Subject: Mariposa Energy Project (09-AFC-03)
Data Response Set 1C, Responses to CEC Staff
Data Requests 2, 5, 8, 9, 48, 56, 59, 61, and 65

DATA RESPONSES, SET 1C

(RESPONSE TO DATA REQUESTS 2, 5, 8, 9, 48, 56, 59, 61, AND 65)

FOR THE
Mariposa Energy Project

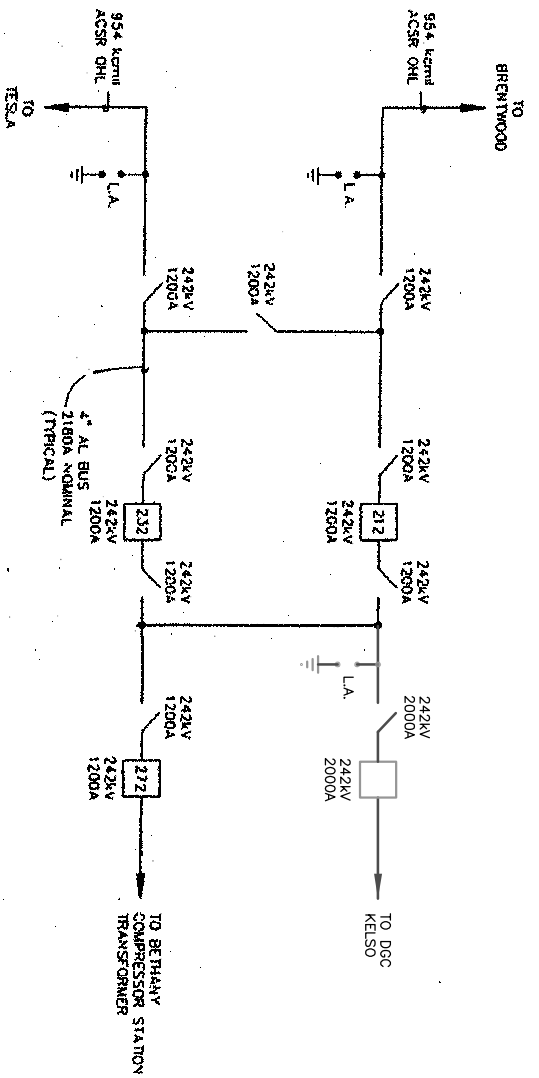
- Reconductor 5 miles of the Vaca Dixon-T275 No.1 230 kV line with bundled 795 Kcmil ACSS or equivalent.
- Reconductor 5 miles of the Vaca Dixon-T275 No.2 230 kV line with bundled 795 Kcmil ACSS or equivalent.

- Installing a new 230 kV switching station for three switch bays with a breaker and a half configuration and looping the Lonetree-Cayetano, Contra Costa-Las Positas, and North-Dublin-Vineyard 230 kV lines.

In addition provide a physical layout drawing of the proposed 230 kV switching station as stated above with major equipments (buses, breakers and disconnect switches) and transmission outlets.

Response:
